# Product Change Notification

## 110749 - 00

**Change Notification #:** 110749 - 00  
**Change Title:** Intel® Server Board S3240GPLX,  
S3420GPLC, S3420GPV, Intel® Server  
System SR1630GP, SR1630HGP, PCN  
110749-00, Label, Korea Communications  
Commission (KCC) mark change  
**Date of Publication:** June 09, 2011

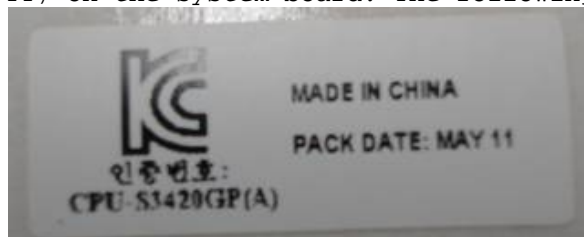
4) Updating the Serial Number label on the chassis to add the manufacturing date (MMM YY). The following is a picture of the old Serial Number label.

The following is a picture of the new Serial Number label.
